RE: Permit No. M-1980-244; Cripple Creek & Victor Gold Mining Company; Cresson Project; Adequacy Review Response to Technical Revision 128 – Ironclad Facilities Access Road Re-Alignment

On July 30, 2021, Newmont Corporation's Cripple Creek and Victor Gold Mining Company (CC&V) received the Division of Reclamation, Mining, and Safety (DRMS) adequacy review of Technical Revision (TR) 128 to Permit M-1980-244, proposing the realignment of the access road from County Road (CR) 821 to the Ironclad Facilities. Below are DRMS comments in **bold** followed by CC&V's responses in *italics*.

ATTACHMENT 2: GM06 STOCKPILE & PROPOSED ACCESS ROAD FIGURES

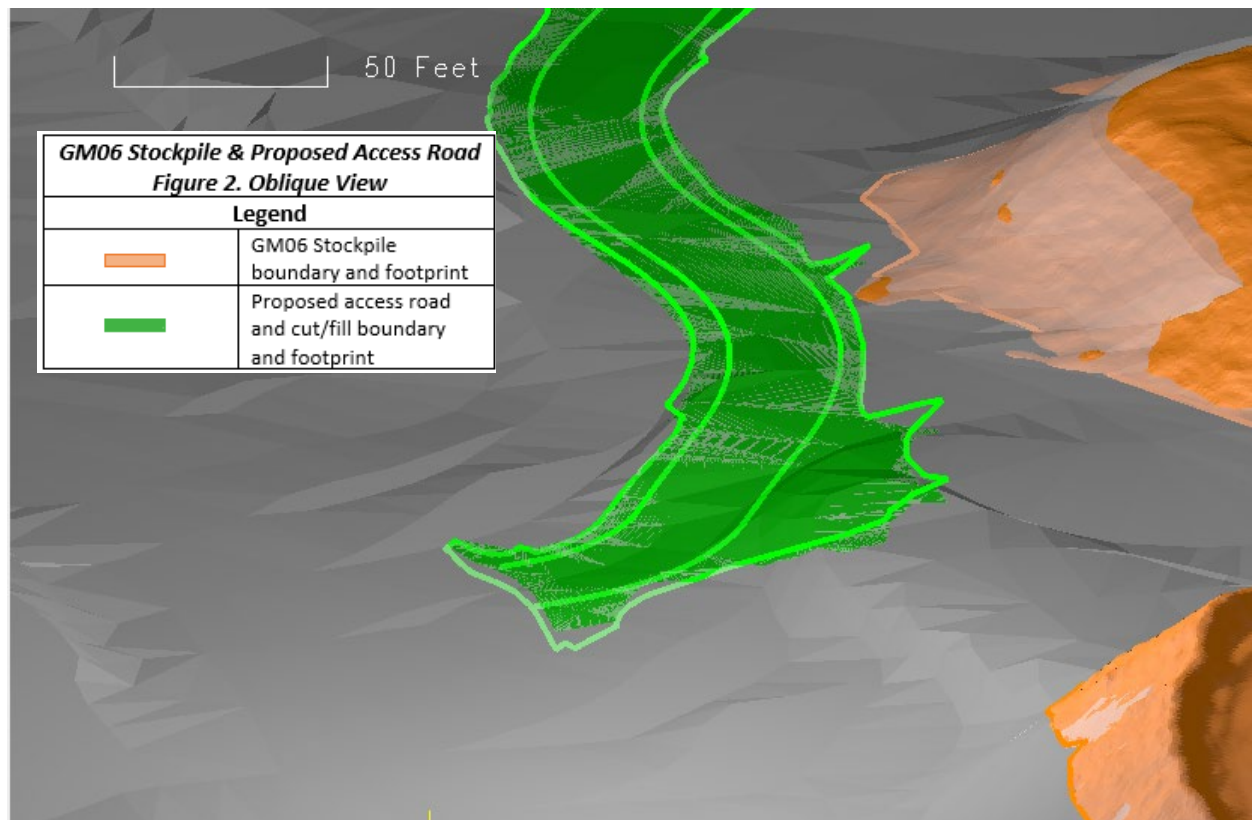
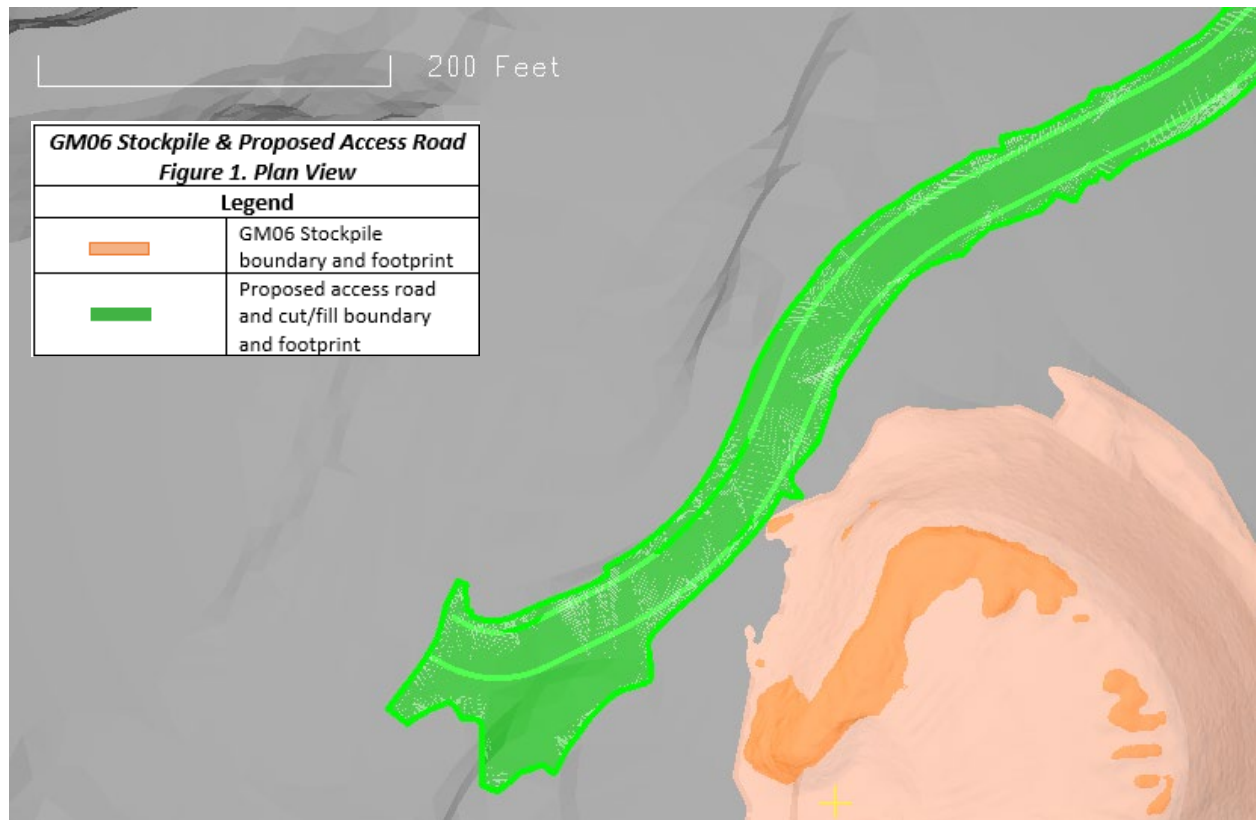
- 2. Drawing A14 appears to depict material from Growth Medium Storage Area 6 which will need to be cut to facilitate the construction of the access road. Please confirm if this material is growth medium and if it is, please address the following:**
 - a. Please provide the approximate amount of material that will be removed. Please confirm this quantity is not included in the 24,500 CY calculation of cut material that will be used as fill for the access road construction.**
 - b. Discuss how the growth media will be handled and where it will be placed.**

GM06 is not anticipated to intersect the access road footprint of the proposed access road. Figures 1 & 2 in Attachment 2 depict the spatial relationship between GM06 and the access road footprint. In the event growth media from GM06 is encountered during construction, material will be removed, placed back onto the GM06 stockpile, graded, and seeded for stabilization purposes.

Figure 1. Overview of the proposed access road, geotechnical cross section locations shown with access road design stations for reference.

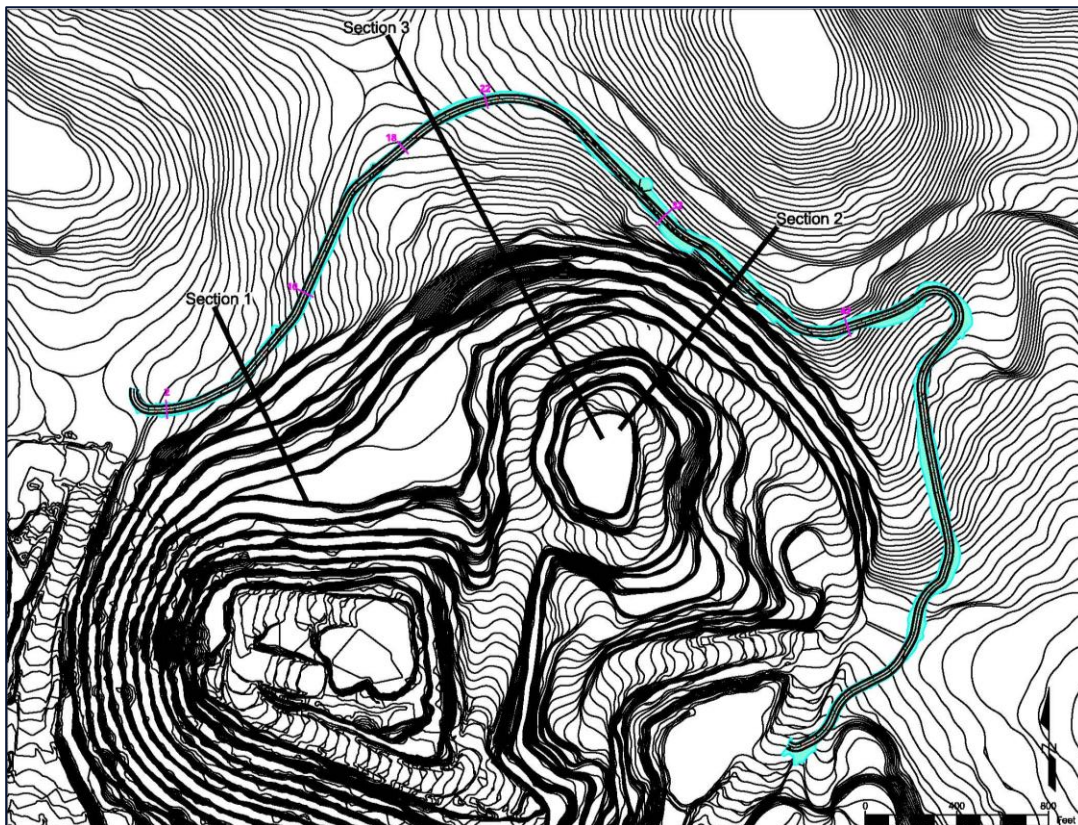
- 9. Please submit a geotechnical stability analysis showing the addition of the road along the crest of the WHEX Pit highwalls does not affect the stability of the highwalls. The analysis will need to specifically cover the portions of the road from Station 2+00 to 10+00 and 32+00 to 42+00. The analyses should account for two simultaneously passing semi-trucks (H-20 loading) within these designated sections of the proposed road.**

The cross sections for analysis were drawn based on requests by DRMS; Section 1 is between stations 2 and 10, Section 2 is between stations 32 and 42, and Section 3 is between stations 18 and 22. The analysis included modeling loaded traffic that would be expected on that road to see what effect there might be on the stability of the road or highwalls below. The properties of the materials used in the analysis and the loading are summarized in Table 1.

The analysis showed that the location of the proposed haul road, as well as the loading from delivery trucks, does not affect the stability of the highwalls. For Cross Sections 1 and 2, average FoS of 1.286 and 1.634 respectively are higher than the minimum allowable FoS of 1.2 (See Appendices 1-6). Cross section 3 shows an average FoS of 1.167 (See Appendices 7-9), but this is a result of the weaker material properties assigned to the Valley Fill material and the low FoS reflects a small bench-slope failure type that does not affect the overall slope. This failure type is consistent with current field conditions and is being managed and monitored by the CC&V Geotechnical group. Monitoring of the ground conditions during the construction of the proposed access road will be undertaken by CC&V Mine Operations and Mine Technical Services. Additional geotechnical monitoring will be installed to ensure the long-term stability of the proposed access road re-alignment.
